ADDENDUM 3 – JOB 23279

TO: All prospective bidders on Projects SS-8-018(106)064, Job No. 23279 scheduled for the December 8, 2023 bid opening.

PLAN ADDENDUM SUMMARY AND APPROVAL

PROJECT INFORMATION		
Project:	SS-8-018(106)064	PCN: 23279
Location:	8 NORTH OF LEONARD, MAPLE RIVER	
Date:	12/5/2023	Lead Designer: Kyle Evert
Bid Opening Date:	12/8/2023	JOB#: 23279 Addendum#: 3

QUANTITIES (ONE BEAM)	
BEAM LENGTH	65.88 LF
MAPLE RIVER	
PRE-TENSIONED 33" X 36" PRESTRESSED SPREAD BOX BEAM	
DRAWING NO.	18-064.955-15

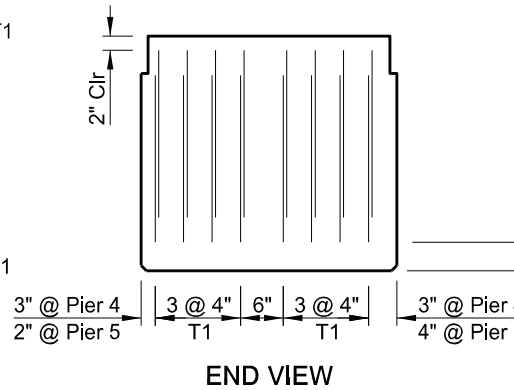
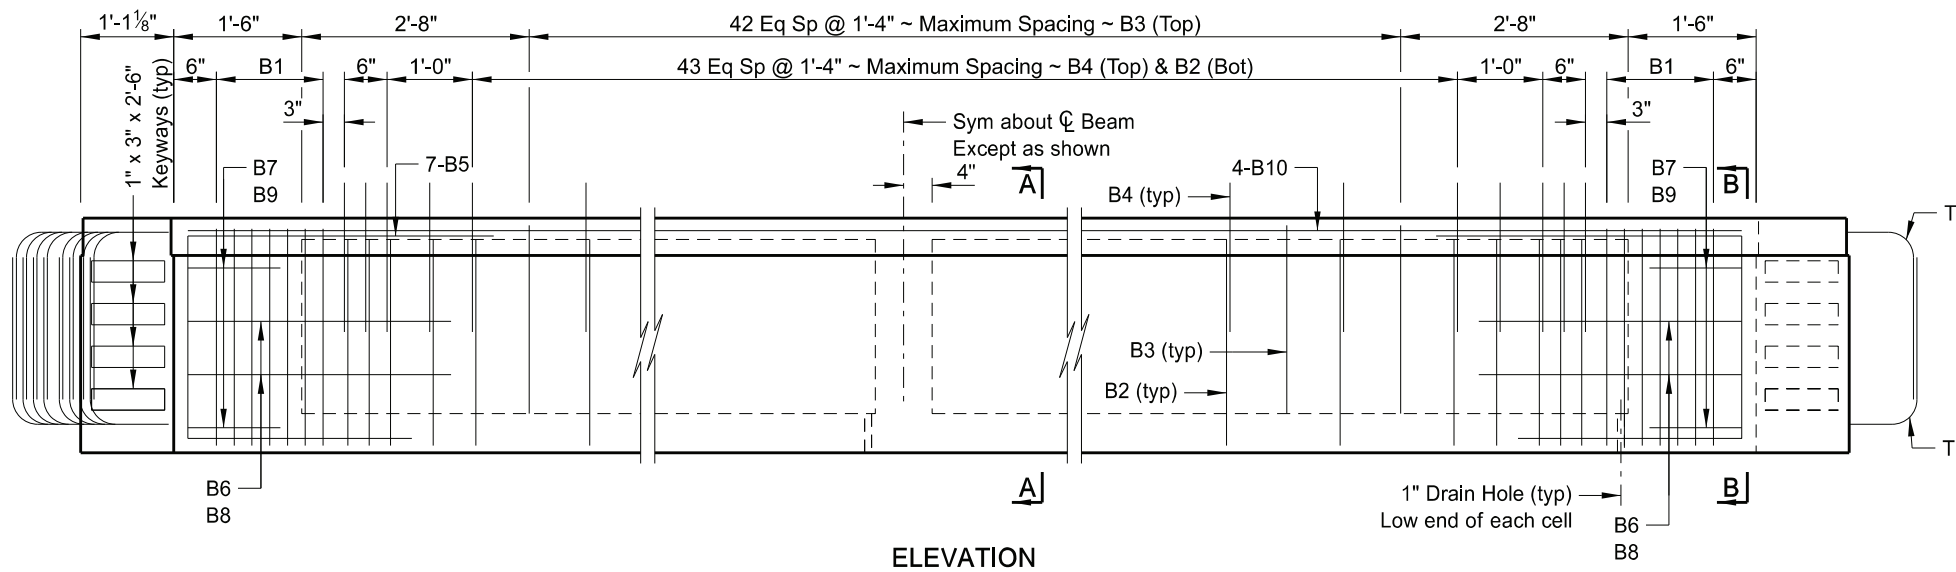
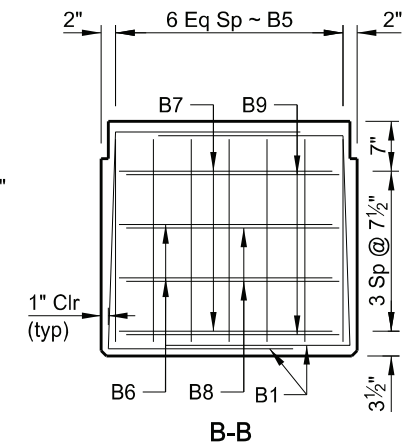
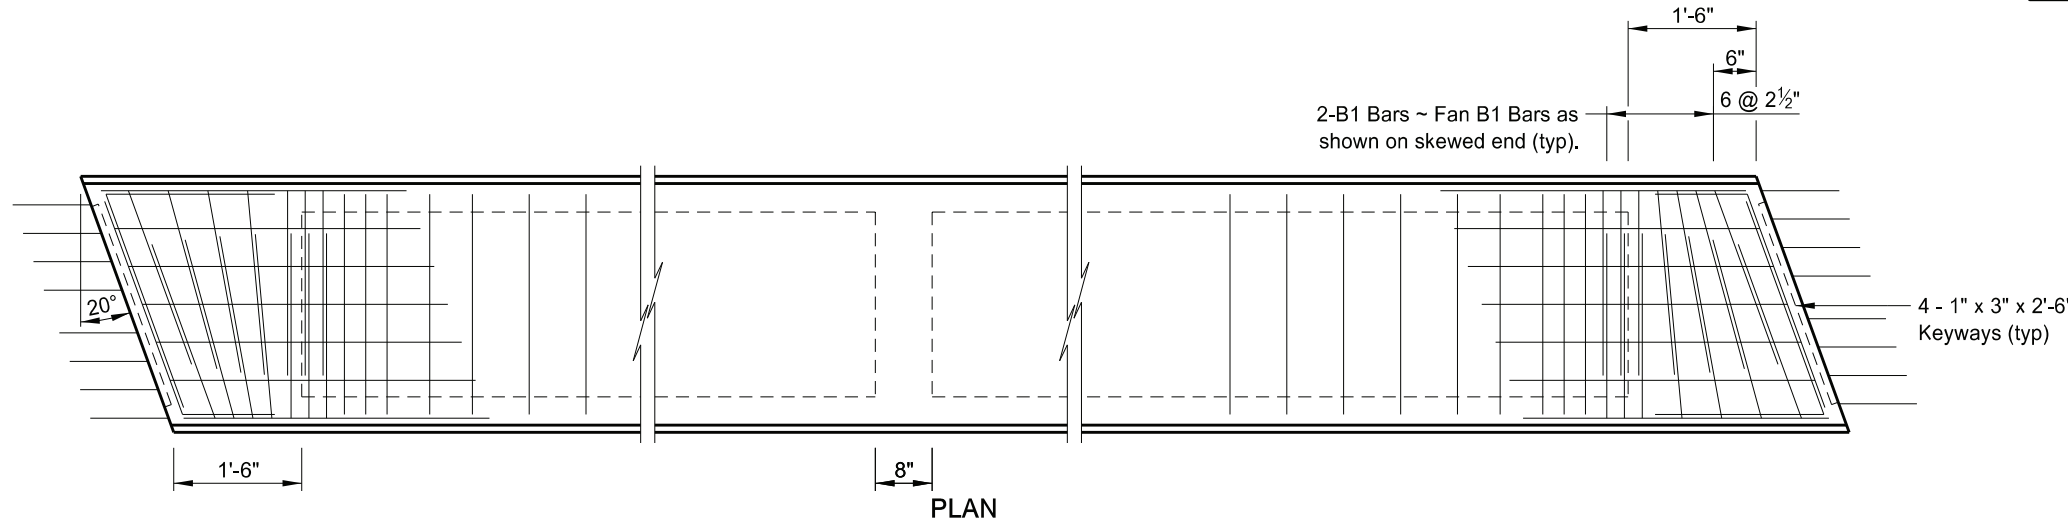
PLAN SHEET CHANGES		
Section	Sheet	Description
2	1	Additional Bid Item required extra page on quantities sheet.
8	1	Added bid item spec 604 Code 9620 PRESTRESSED BOX BEAM-33IN
170	4	Added bid item spec 604 Code 9620 PRESTRESSED BOX BEAM-33IN to Bridge Bid Items
170	15	Adjusted beam length from 65.83 LF to 65.88 LF
170	17	Double dimension added to detail
